FACPAC Contract Change Order

Tier 1 Project: Estill Springs Elementary Phase 2 Renovations & Addition - ESSER III
 BG Number: 22-207 District: Estill County (HB678)
 Status: Active Phase: Project Initiation (View Checklist)

CHANGE ORDER NUMBER: 02-09
INITIATION DATE: 8/2/2023

PROJECT: Estill Springs ES Phase 2 Ren-Add 2148 DATE SENT: 6/27/2023
RETURN BY: 7/11/2023
SUBJECT: PR 14 - Revised Masonry Section Detail PROPOSAL REQUEST ID: PR 14
TYPE: Proposal Request TRANSMITTAL ID: 00546
PURPOSE: For Contractor's Pricing VIA: Info Exchange

PR14.1 – REVISED MASONRY SECTION DETAIL

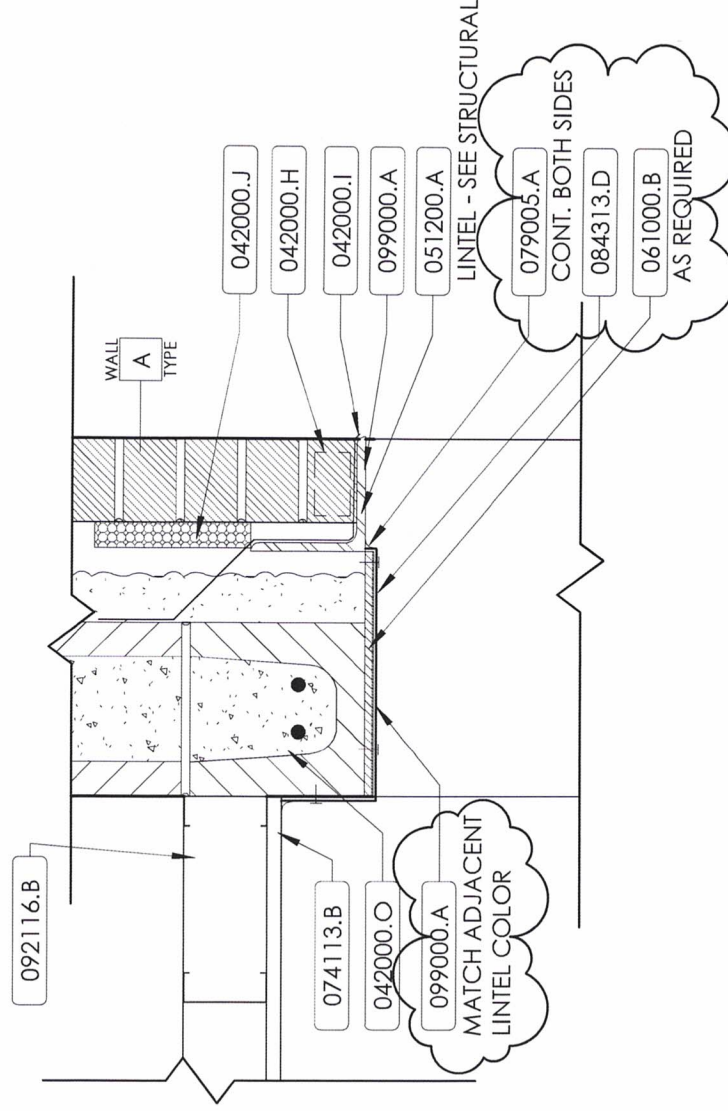
Contractor to provide a detailed price breakdown for all labor, material, and equipment costs per the following and attached sketch to correct an observed site condition.

- Revise detail H/A5.1 per attached sketch to close cavity in masonry wall.
- Proposal to price substrate/plywood, brake metal, paint, and joint sealant.
